**ADDENDUM No. 2**  
**Request for Competitive Sealed Proposals (CSP)**  
**19CSP104 Renovations at Dobie Middle School**

**Addendum No. 2**

**TO:** Prospective Bidders  
**FROM:** Haddon+Cowan Architects  
**SUBJECT:** AISD Dobie Middle School Renovations

**DATE:** February 15, 2019  
**HCA PROJ. NO:** 18-1032  
**AISD PROJ. NO:** 190035-DOBIE

**1** MEP NEW ROOF PLAN  
 MEP2.2  
 1"=20'-0"

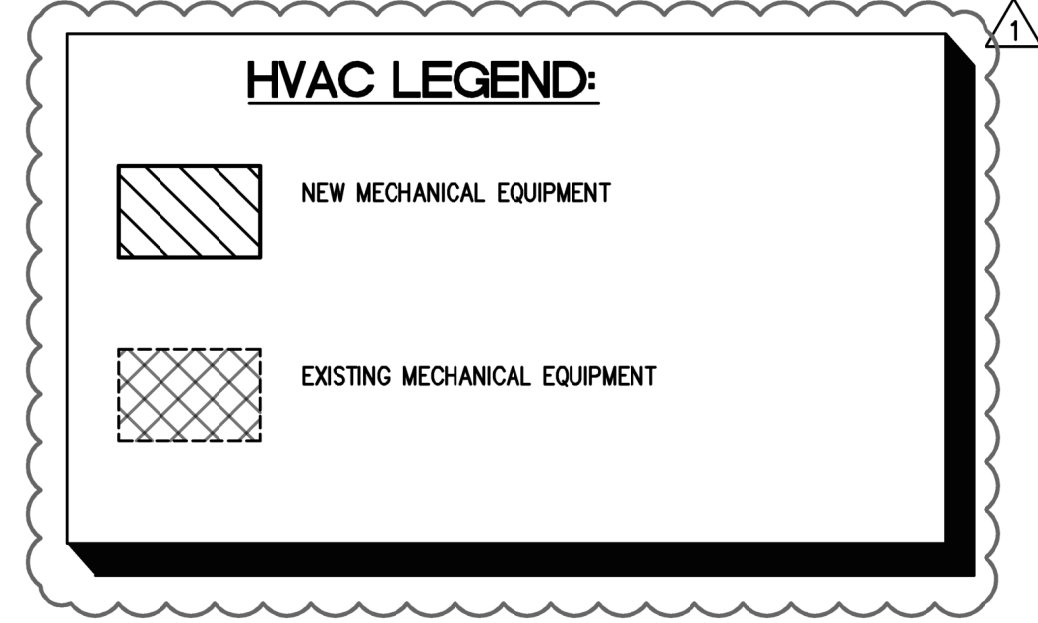
- a. Legend has been updated.
  - b. Keyed note number 2 has been revised to mention re-using the existing curbs in place, and to provide curb adapters.

- c. Updated keyed notes 4 & 5 to reflect a single cooling tower with (2) cells.
10. Sheet MEP2.3 – Revised and Reissued
  - a. Legend has been updated.

- 2 PROVIDE REPLACEMENT MAKE UP OUTSIDE AIR UNIT. UNIT SHALL BE INSTALLED IN SAME LOCATION AS PREVIOUSLY REMOVED UNIT PROVIDING NEW CURB ADAPTER AS NEEDED TO MEET 18" MINIMUM HEIGHT REQUIREMENT WHILE REUSING EXISTING CURB. PROVIDE FITTINGS AS REQUIRED TO CONNECT TO EXISTING DUCTWORK. INSTALL UNIT PER MANUFACTURER'S INSTALLATION INSTRUCTIONS AND PROVIDE ALL REQUIRED CLEARANCES. PROVIDE NEW CONDENSATE LINE TO MATCH PREVIOUSLY REMOVED PIPING. CONDENSATE PIPING SHALL BE ROUTED AND SIZED TO MATCH PREVIOUSLY REMOVED LINE SERVING UNIT.

1 ENLARGED COOLING TOWER MEP ROOF PLAN  
MEP2.3 1/4"=1'-0"

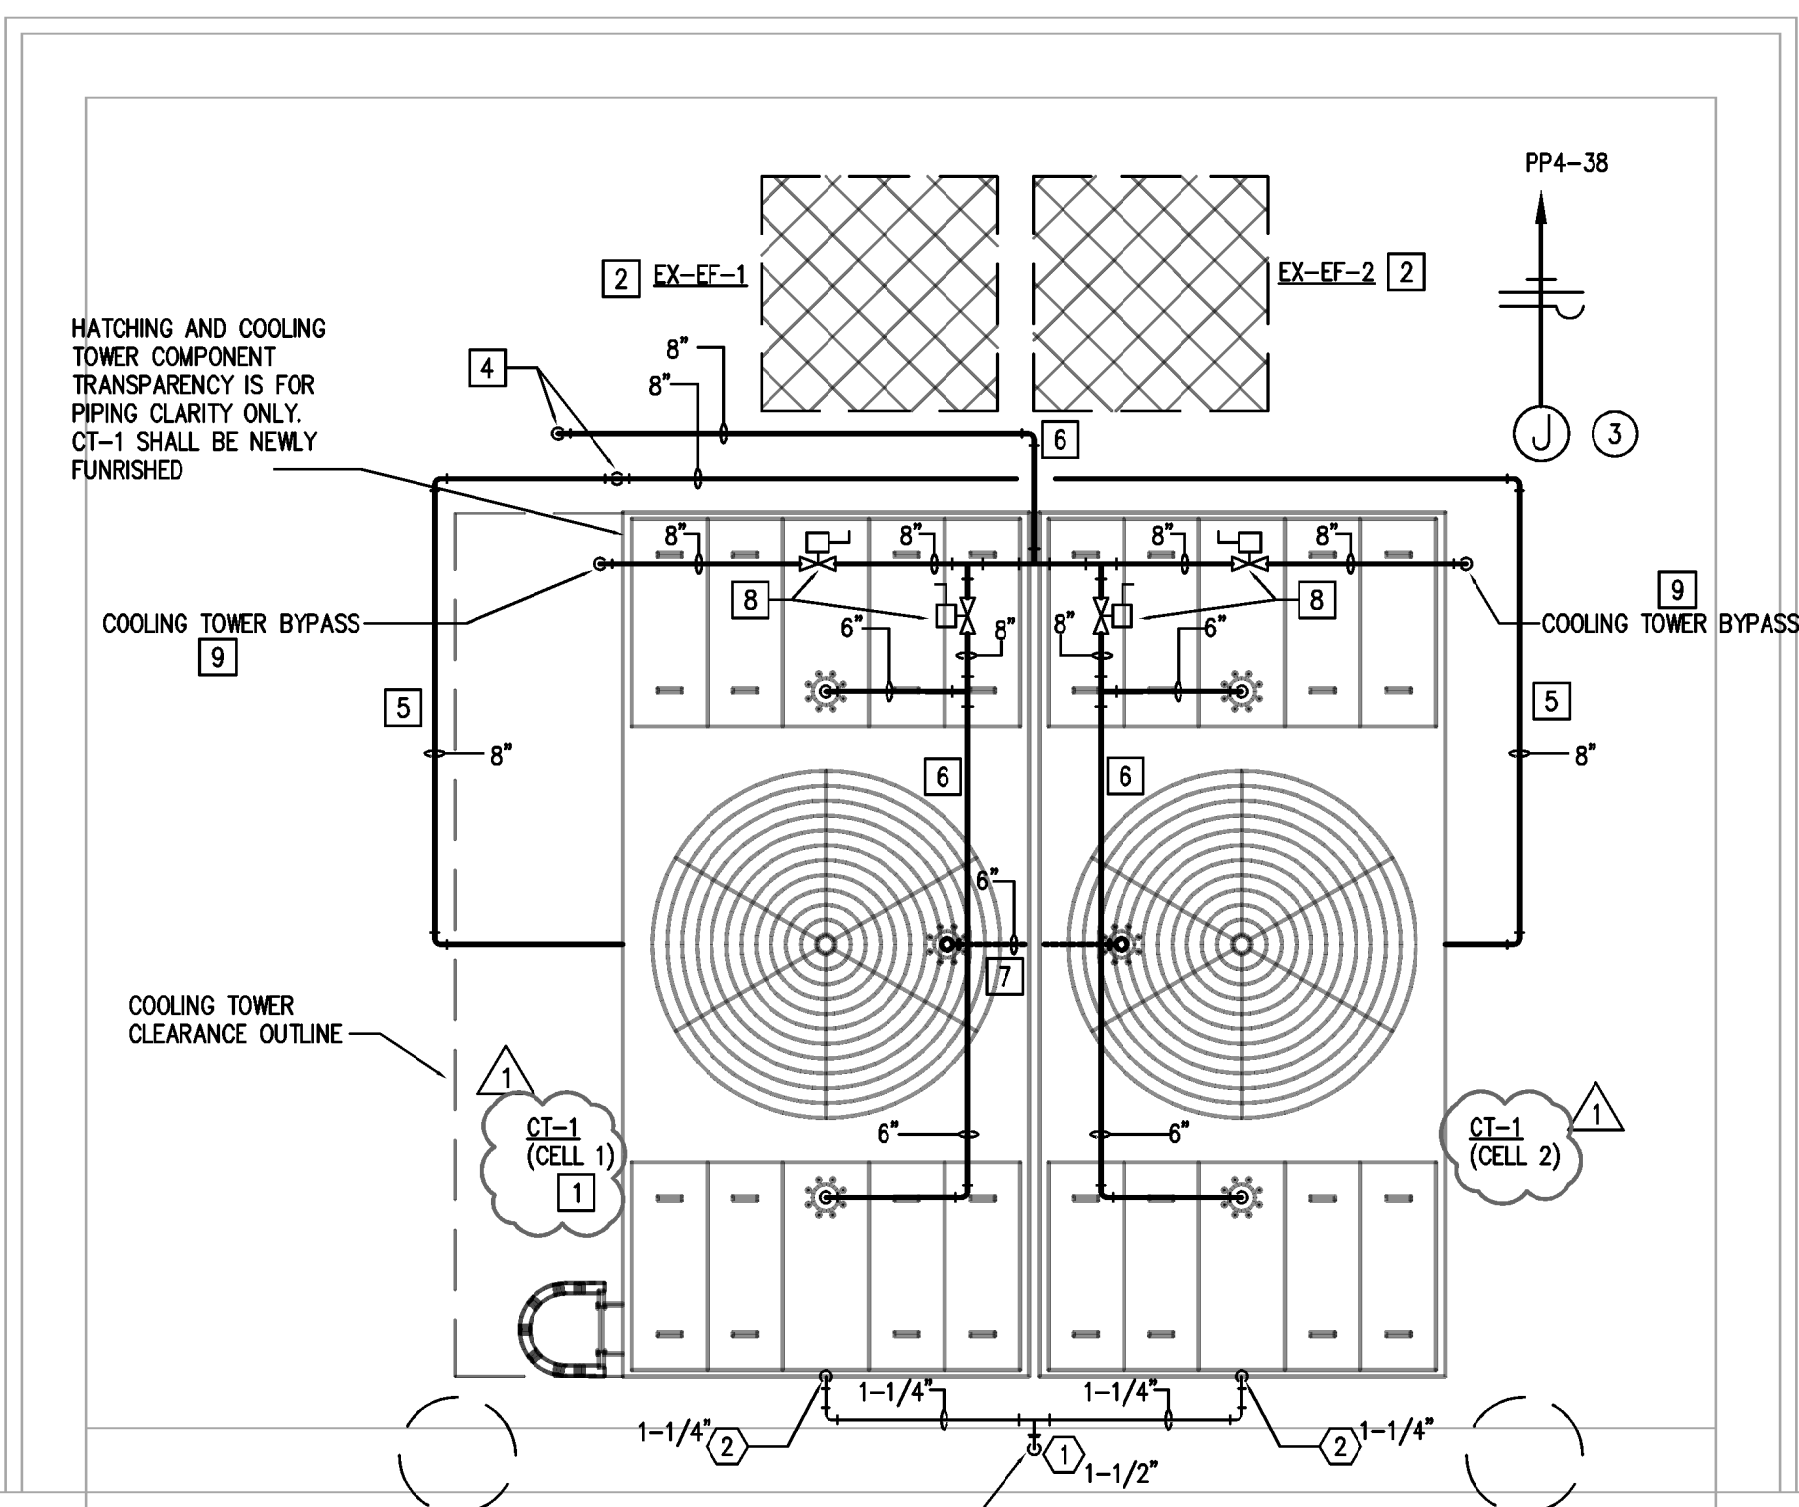
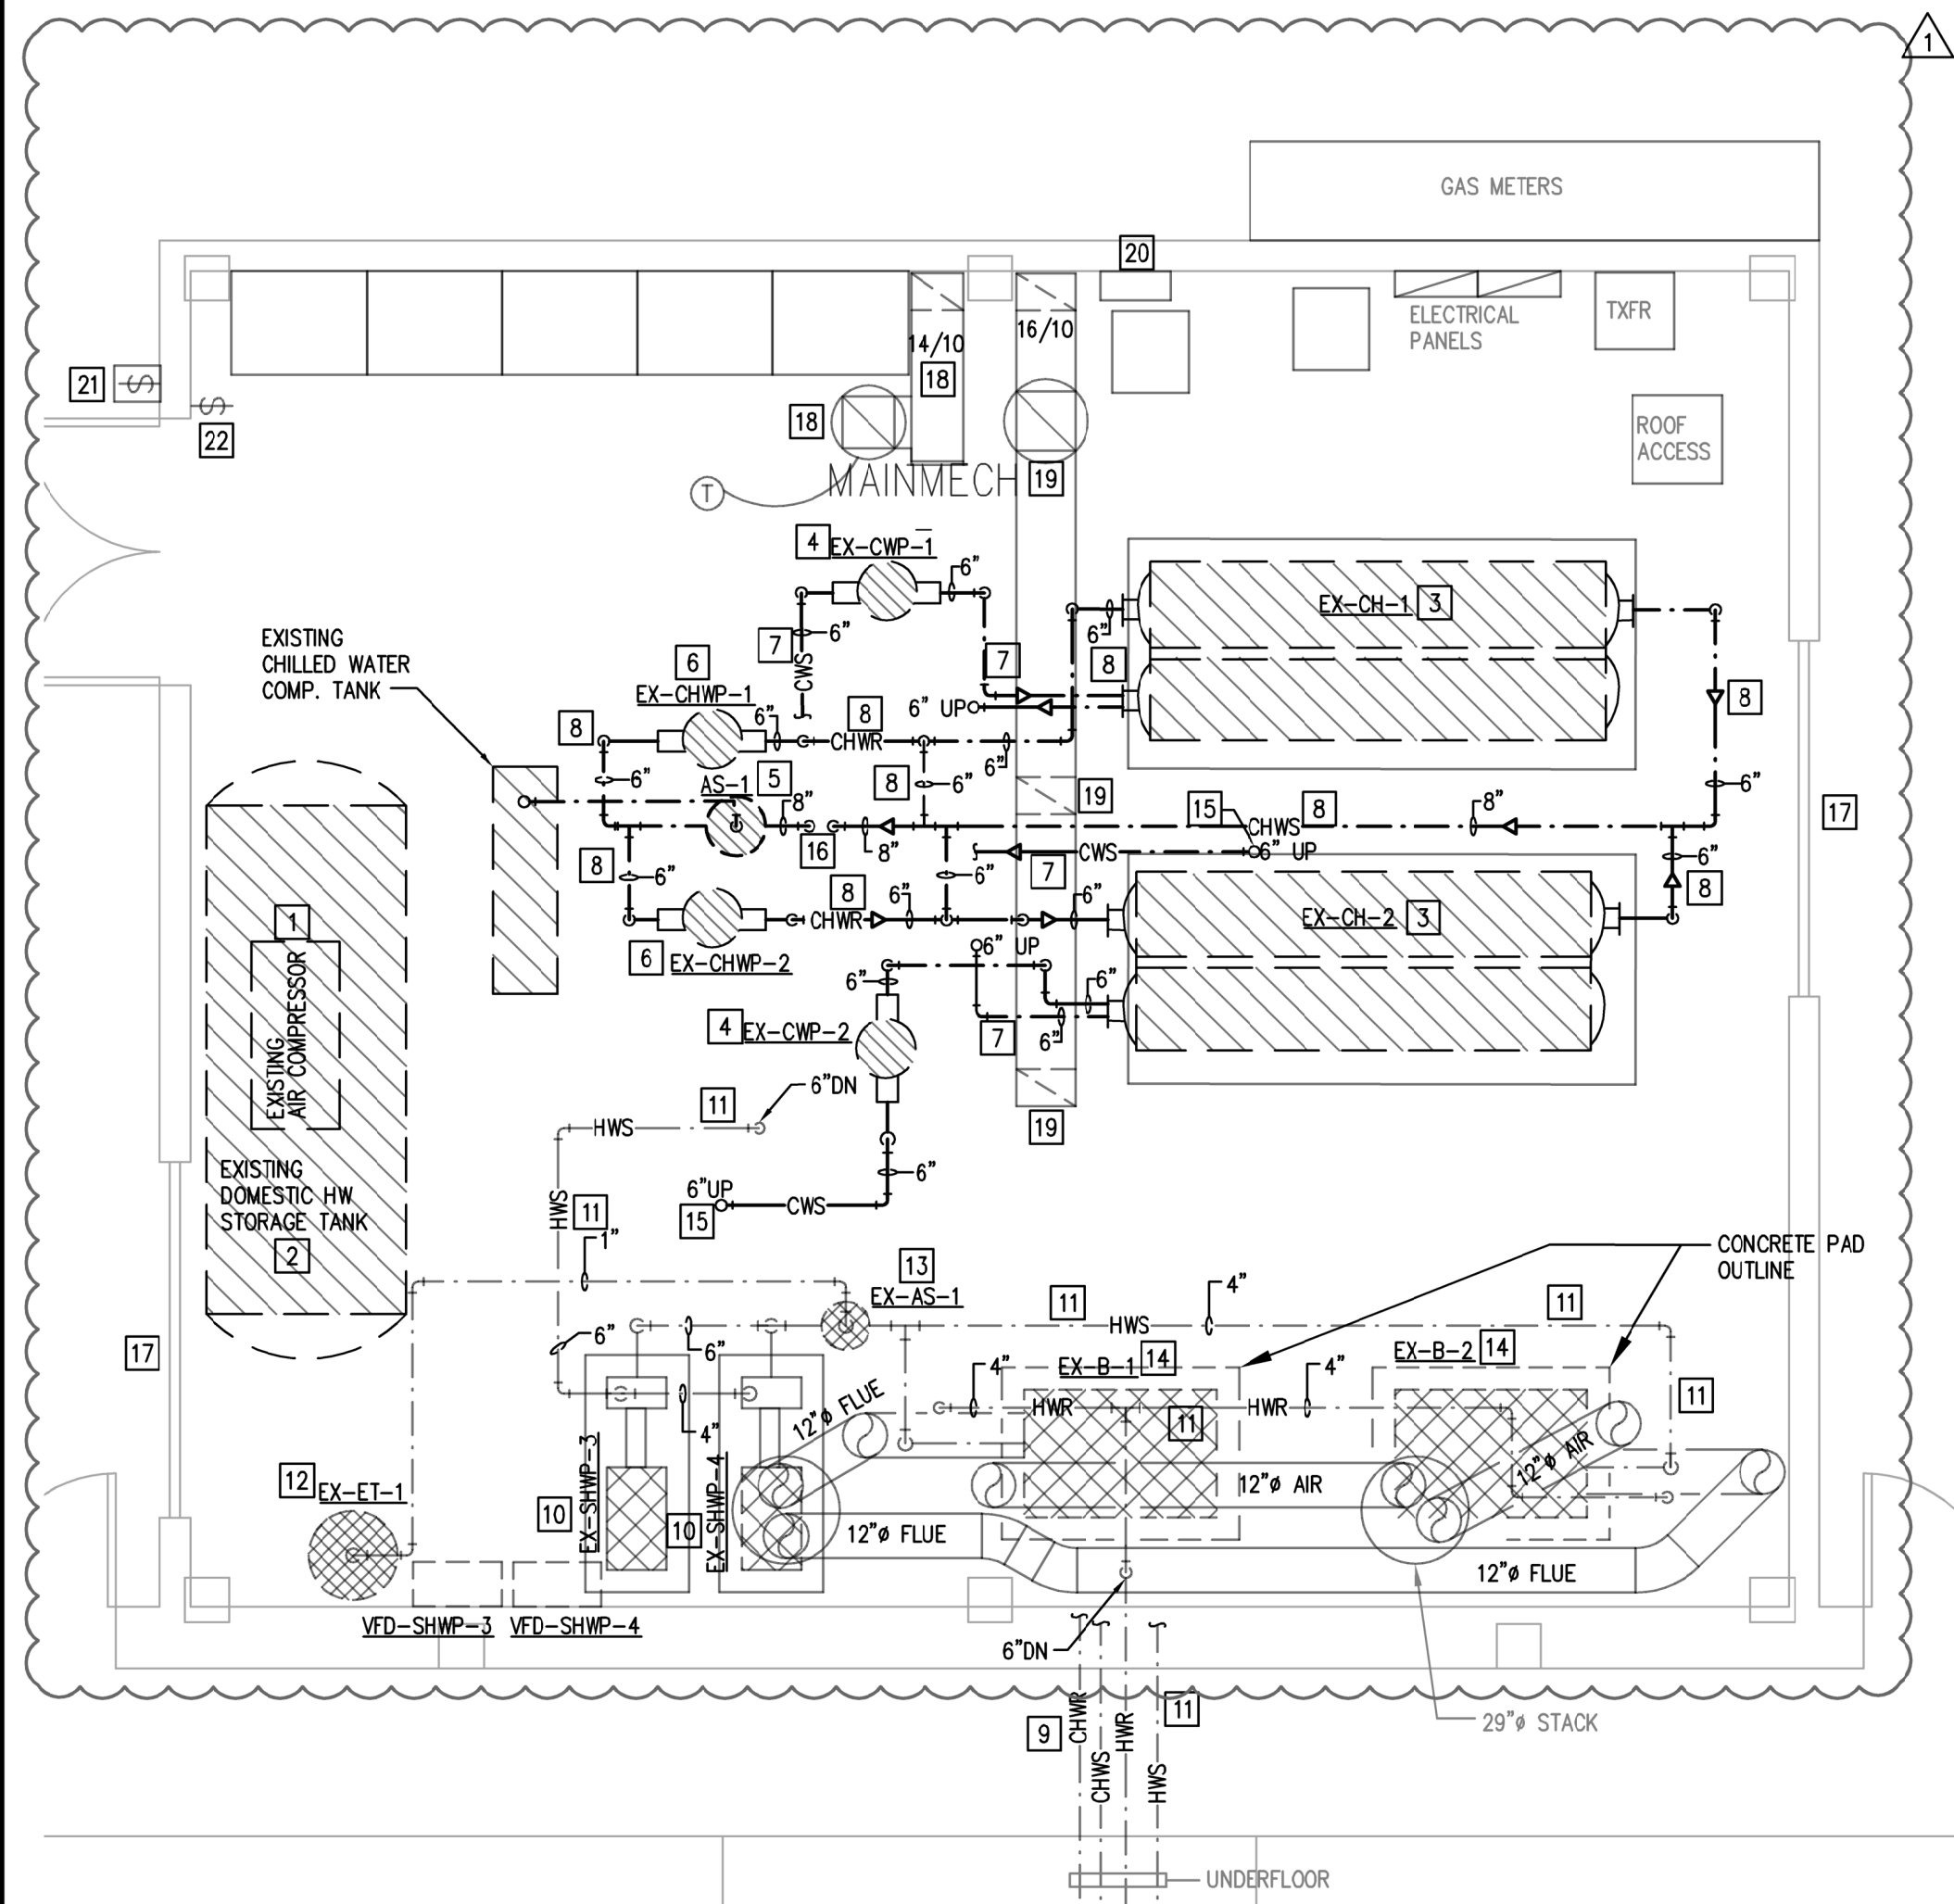
- b. Reference to CT-2 has been removed. There is one tower, two cells. The notes have been revised for clarity.
  - c. Updated keyed notes 4 & 5 to reflect a single cooling tower with (2) cells.

**2 MAIN MECHANICAL ROOM NEW PLAN**  
 M3.1 1/4"=1'-0"

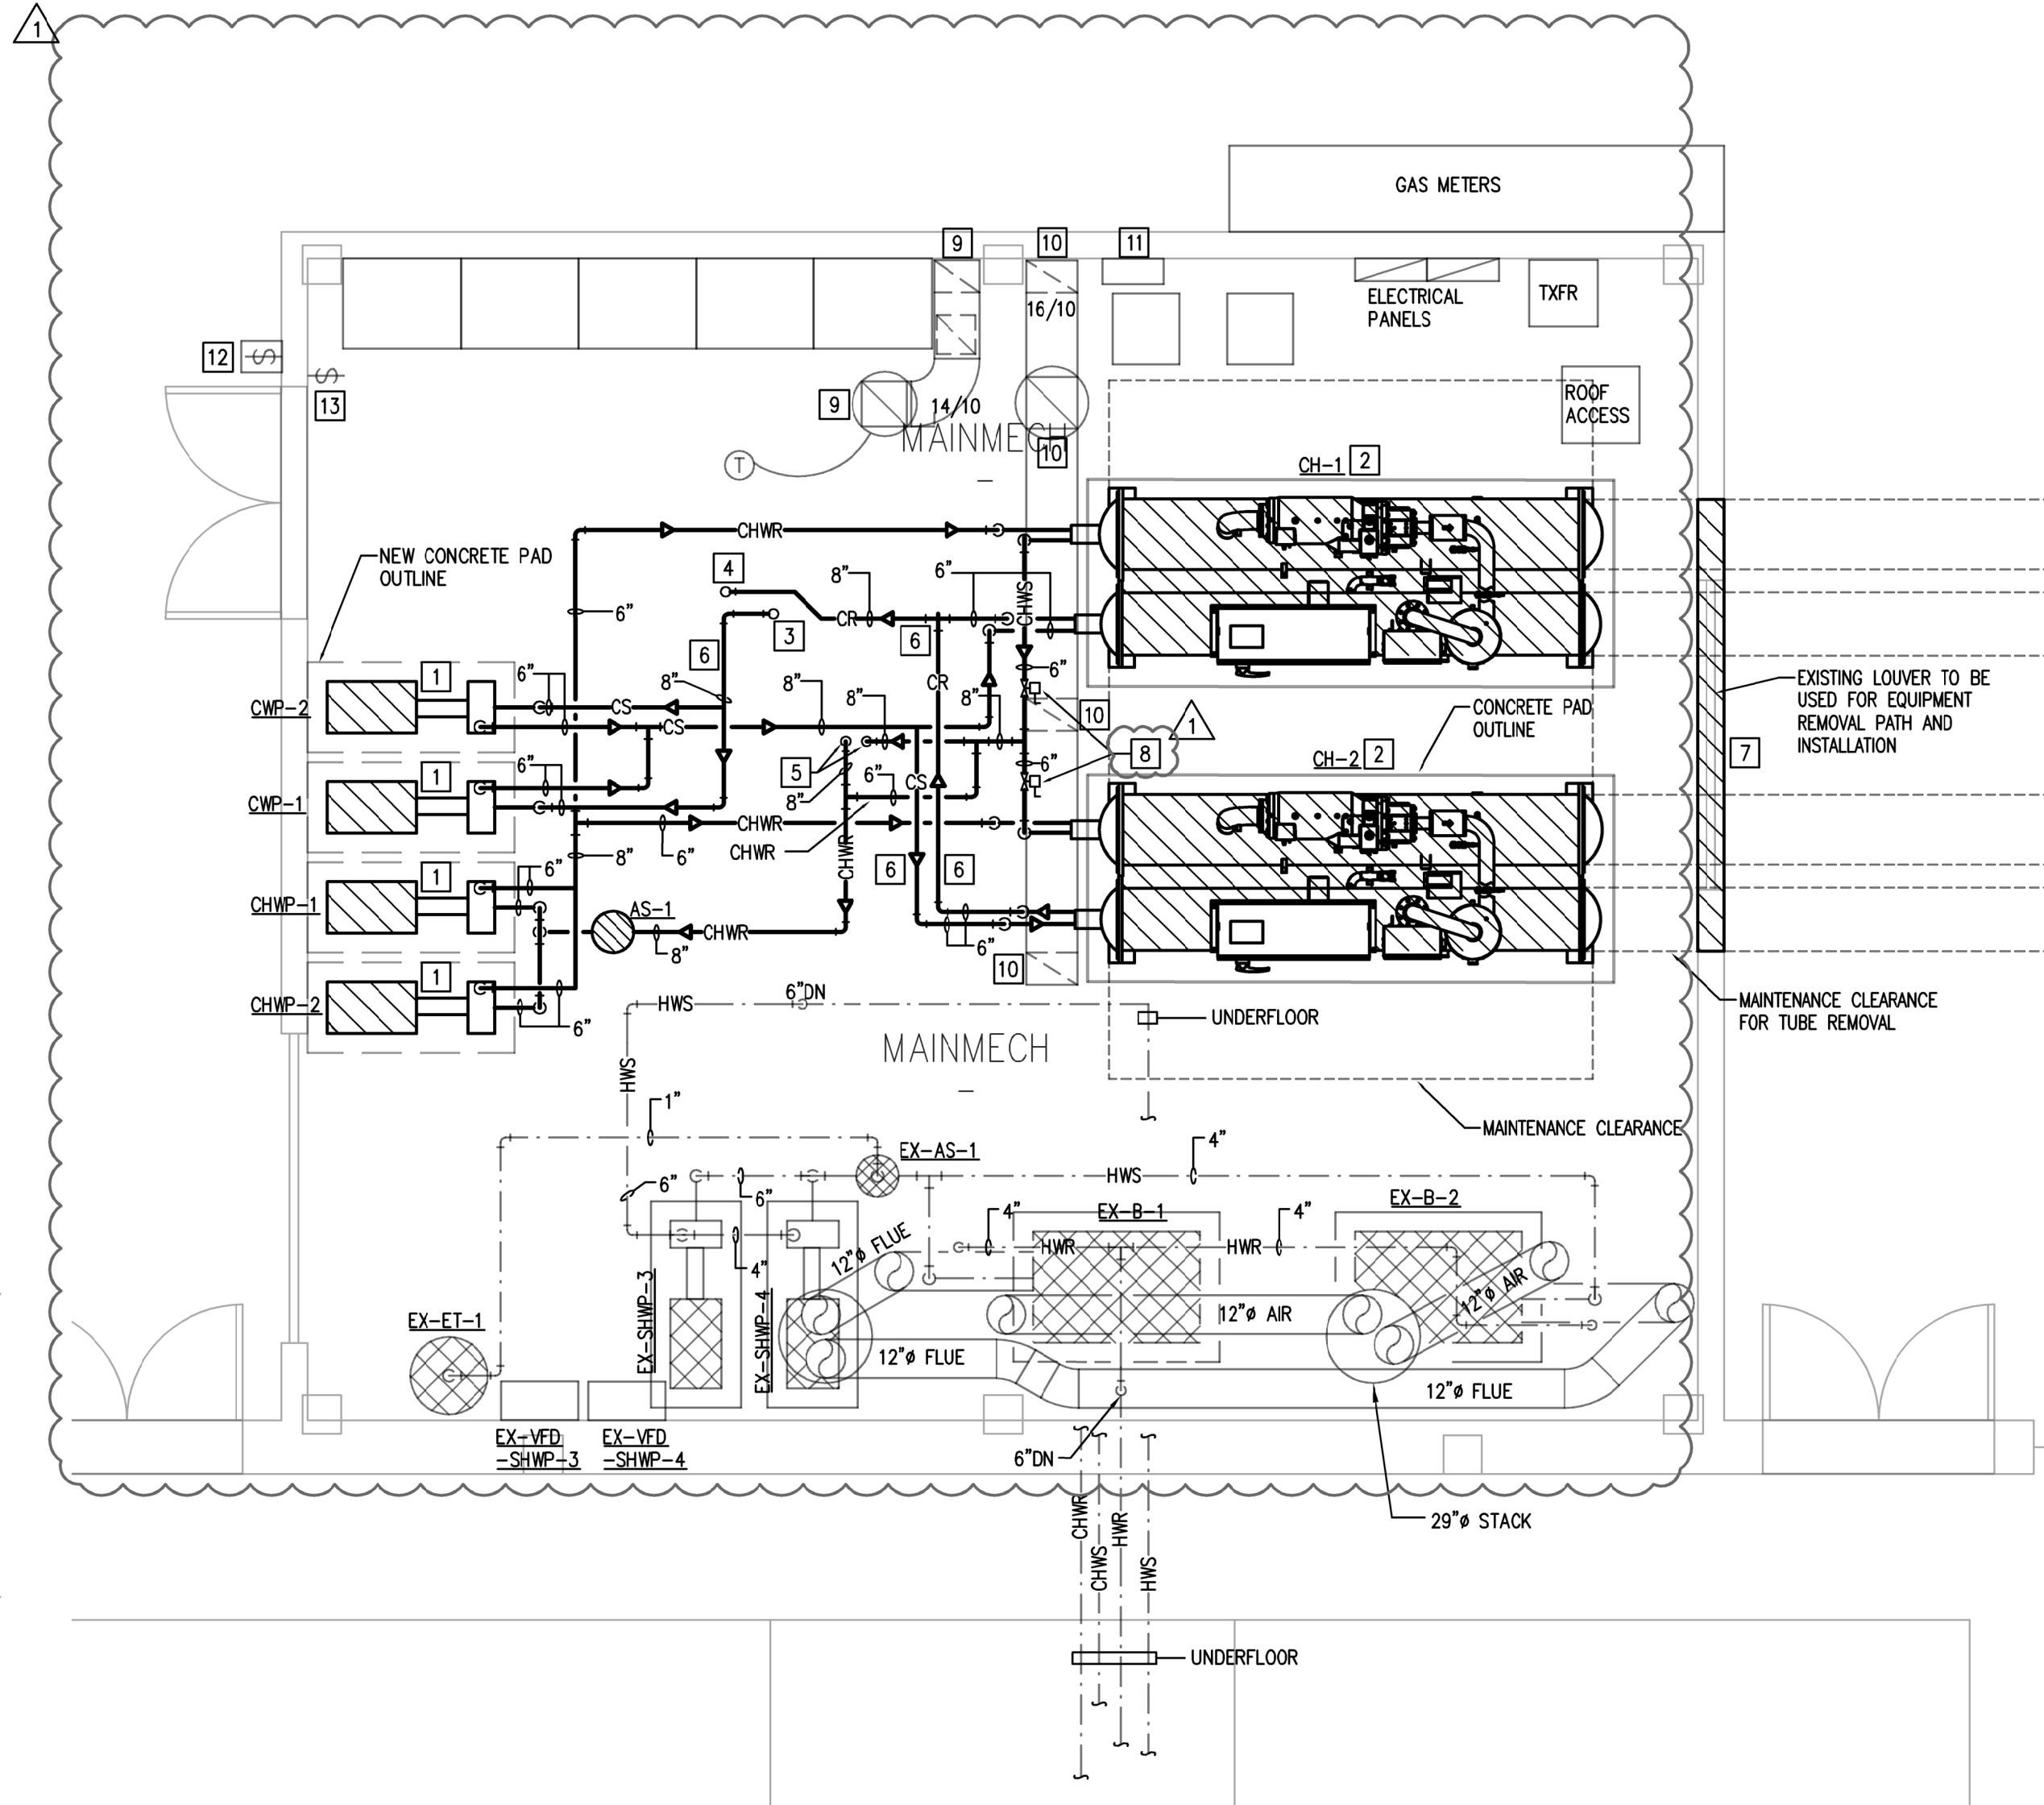
11. Sheet M3.1 – Revised and Reissued
  - a. Keyed note referring to motorized isolation valves have been revised to show the correct keyed note number.

- c. Keyed note 1 is now matching M6.1/5 for providing new concrete pads for new pumps.
  - d. HVAC legend has been updated to provide more clarity between existing and new equipment. Note that only the legend has been clouded to show the difference in hatching.

- e. All existing equipment marks have been revised to clarify whether it is existing or new.
12. Sheet M3.2 – Revised and Reissued
  - a. Legend has been updated.

- 1 PROVIDE NEW 4" THICK CONCRETE PAD FOR NEW CHILLED WATER AND CONDENSER WATER PUMPS. PAD SHALL EXTEND 6" BEYOND FOOTPRINT OF PUMP FRAME. RE: DETAIL 5/M6.1.
